MODEL  
2019-2020MY  
Sedona (YP)

NUMBER  
194 (Rev 2, 12/23/2019)

SUBJECT: SERVICE ACTION: TAILGATE GAS LIFT INSPECTION  
AND/OR REPLACEMENT (SA398)

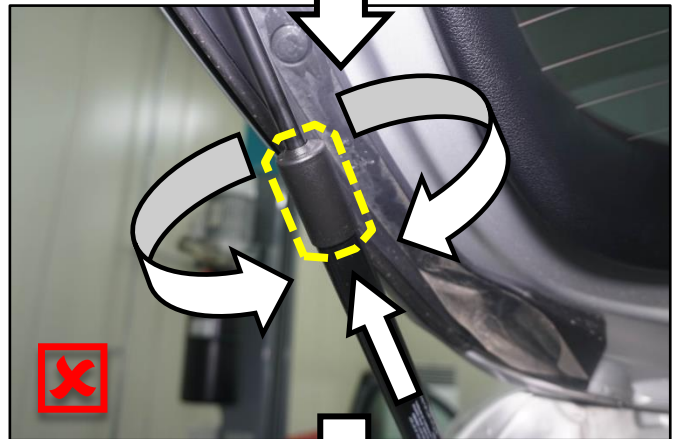
1. Open the tailgate door and locate the gas lifts (A).

2. Inspect both of the tailgate gas lift dust covers (B) for the following failures:

- Unable to turn/rotate
- Slide upward
- Visual cracks

If any of the above conditions **are present**, refer to stop 3 and replace the affected tailgate gas lift(s).

3. Remove the tailgate gas lift(s) by referring to the “Body (Interior and Exterior) → Tail Gate → Tail Gate Lift → Repair procedures” chapter in the applicable Shop Manual on KGIS.

4. Install all removed parts in the reverse order of removal.

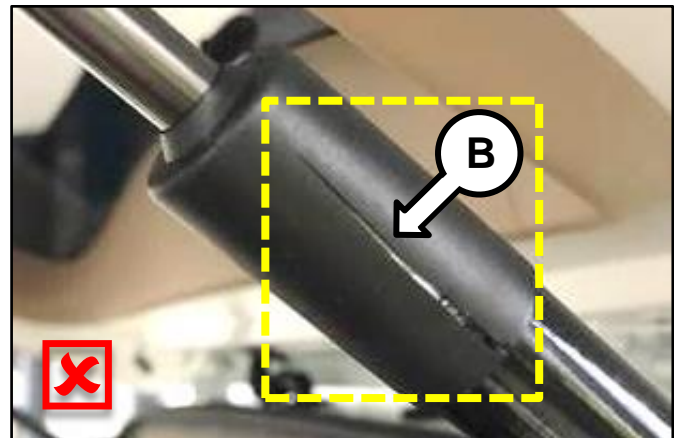
If any of the dust cover(s) conditions **are not present**, this action is complete.
